Startup Resolutions for 1000BASE-T

**Sailesh K. Rao
Level One Communications, Inc.**

Outline

D1.2 PHY Control

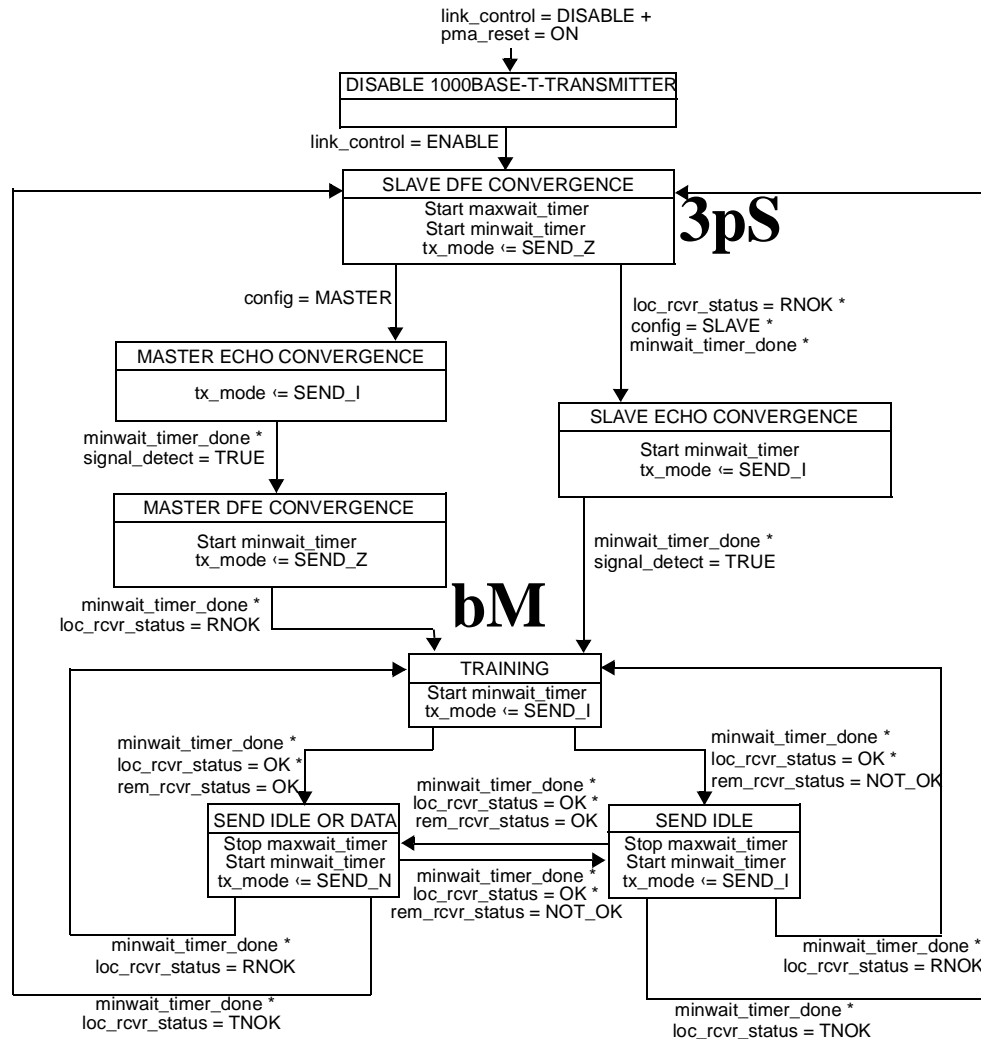
Synchronization Problem

Synchronization Problem

- Occurs primarily due to Blind PHY/ 3-phase Sequenced Startup PHY interoperability requirements

Pointed out John Creigh in Comment 69 on D1.1.

- Example problem:

Blind Master transitions to Training State due to

signal_detect = TRUE (noise burst/magnified AGC) in presence of Echo in Master Echo Convergence state - John Creigh reflector e-mail of 1/23/98

Blind Master PHY does nothing during Master DFE Convergence state

3-phase Sequenced Startup Slave PHY is still in auto-negotiation

Agazzi/Creigh PHY Control Diagram

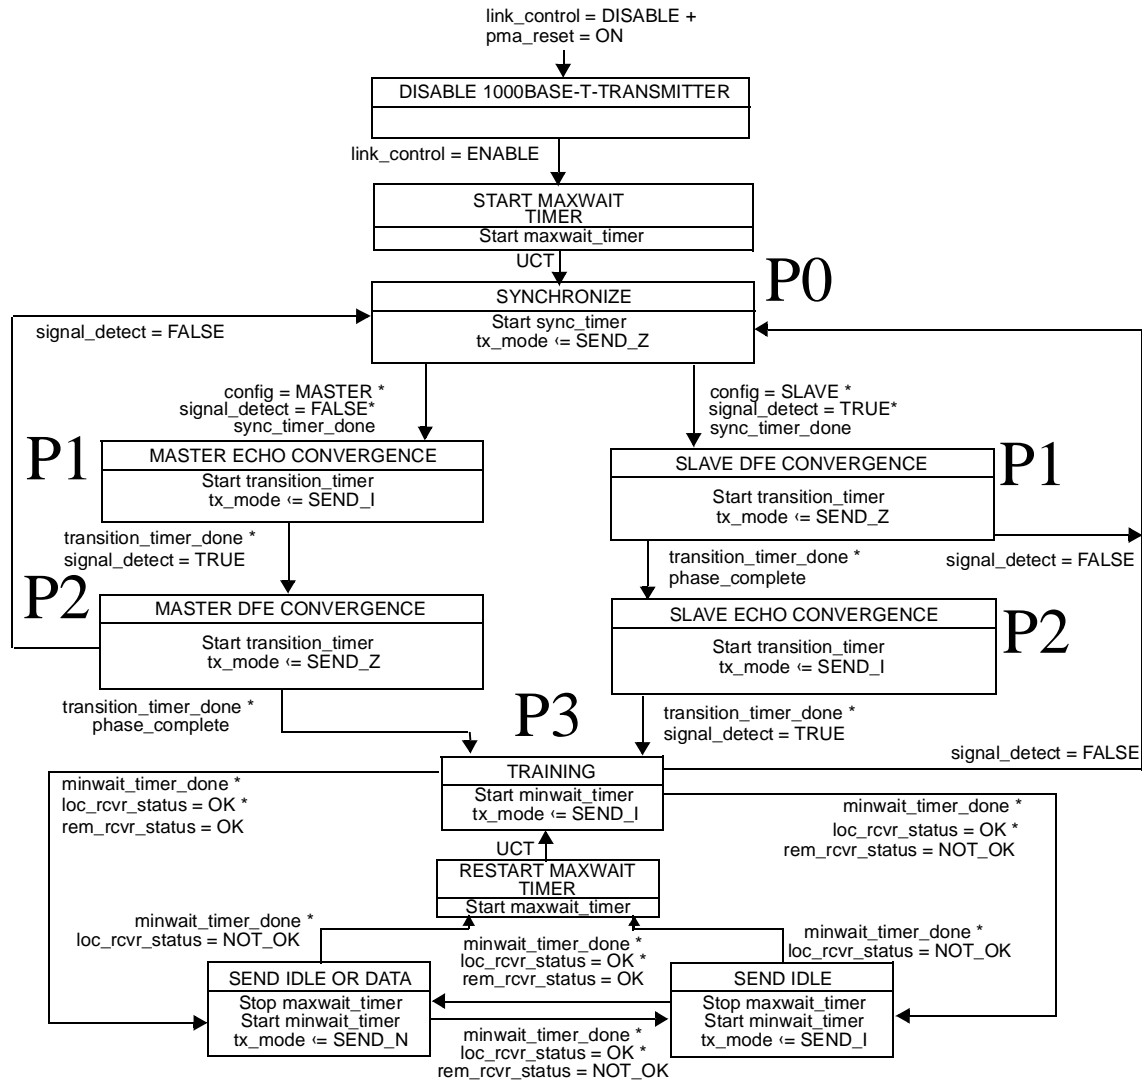
Problems with the A/C resolution

- “Process Problem”:
consistent with Montreal Protocol?
- Technical Problems (BM/BS, 3PM/BS, BM/3PS, 3PM,3PS)
 1. Phase Multiplication Problem (All 4 combinations)
 2. Phase Chasing Problem (BM/3PS, 3PM/3PS)
 3. Continuance of Synchronization Problem (BM/3PS, e.g.)
 4. Signal Detect Compliance Problem.

Phase Multiplication Problem

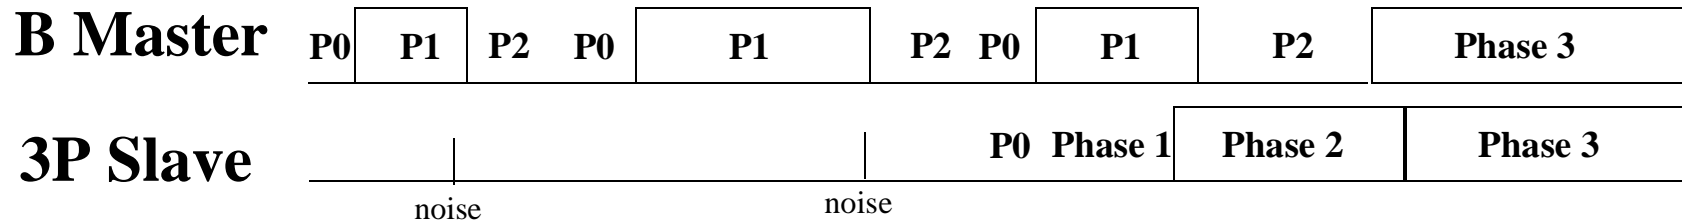
- Number of On/Off phases can multiply to indefinite values, even when startup is successful and even for Blind PHY implementations.

- Example: solved synchronization problem of D1.2, but Blind Master PHY had to do 8 ON/OFF phases.

Phase Chasing Problem

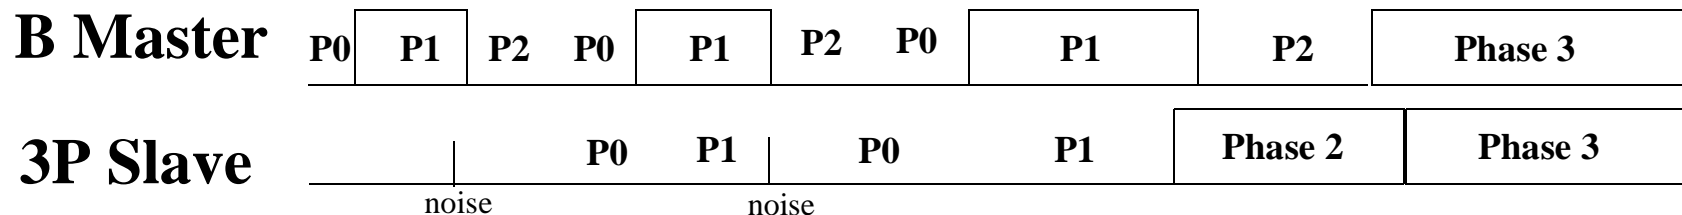
- If Master does Phase 0/1/2 loop, Slave must do Phase 0/1 loop!
- Potential difficulty in DFE convergence if Slave resets FFE/DFE in Phase 0, since this is supposed to be the START phase.
- Note: Blind Slave can just ignore Master ON/OFF phases since it ignores Phase 1. Here FFE/DFE convergence will not be an issue.

Continuance of Synchronization Problem

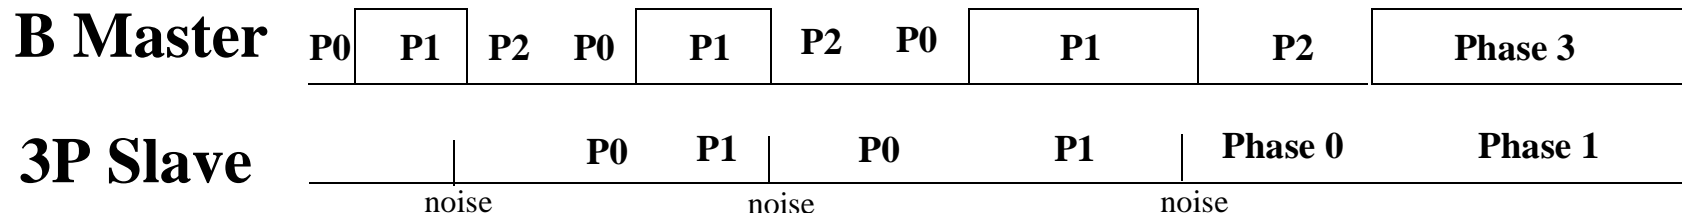
- Probability of Synchronization problem is much reduced.
- Synchronization problem will occur if for some reason (e.g., noise immunity tests being conducted on PHY, bad signal_detect=FALSE implementation), Blind Master skips signal_detect=FALSE transition in Phase 2.
- In example below, only option for 3P Slave is to do 2-phase sequenced startup.

- Note: “noise” could be just poor signal_detect implementation in presence of Echo.

2. Fixed Timer Approach

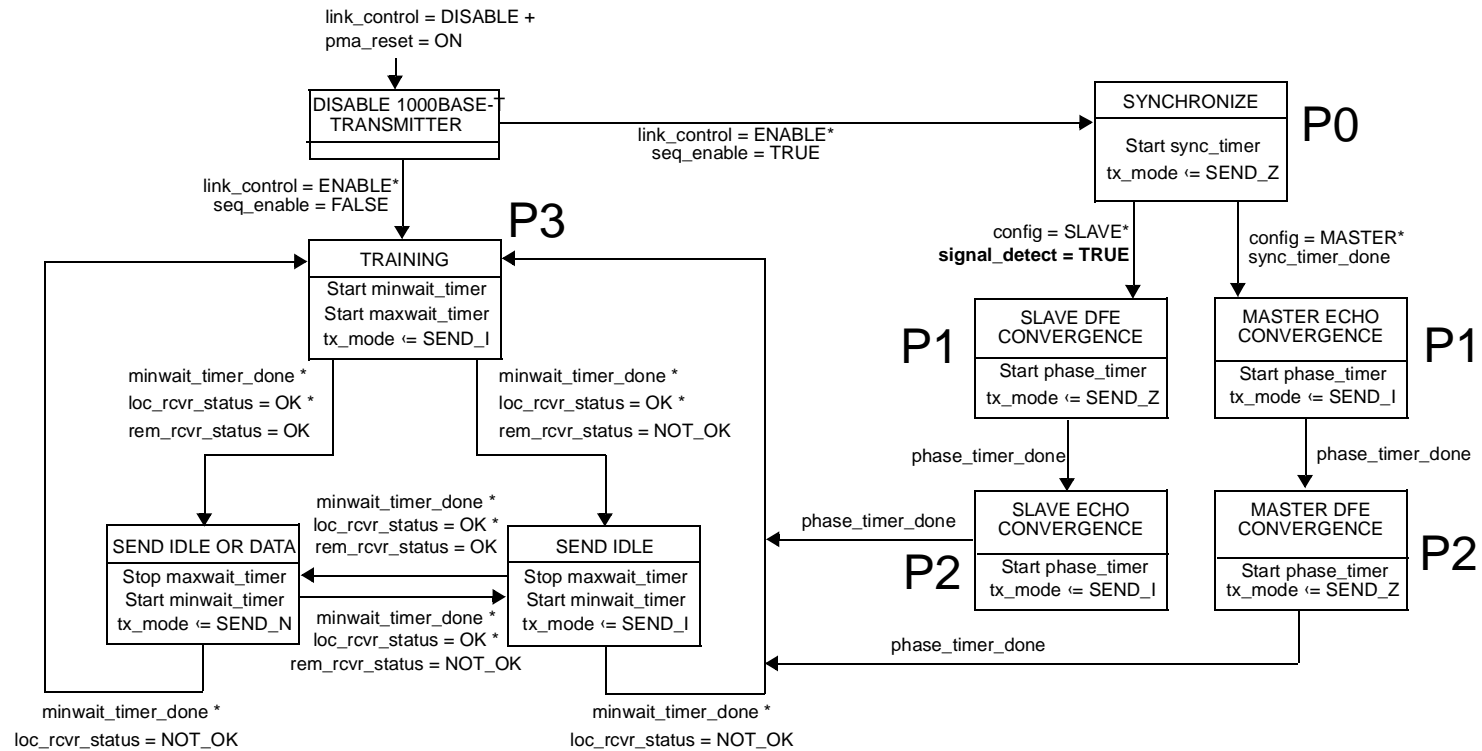
fixes all timer values and potentially restricts implementation choices

uses 3-phase sequencing only during startup and not during retraining

initial delay of 200ms to cover auto-negotiation variability is a fixed penalty on three PHY combinations (3PM/BS, 3PM/3PS, BM/3PS)

- **2. Fixed Timer Approach:** Insert Phase 0 as in A/C resolution, but use fixed timers and initial delay on Master PHY transmission.
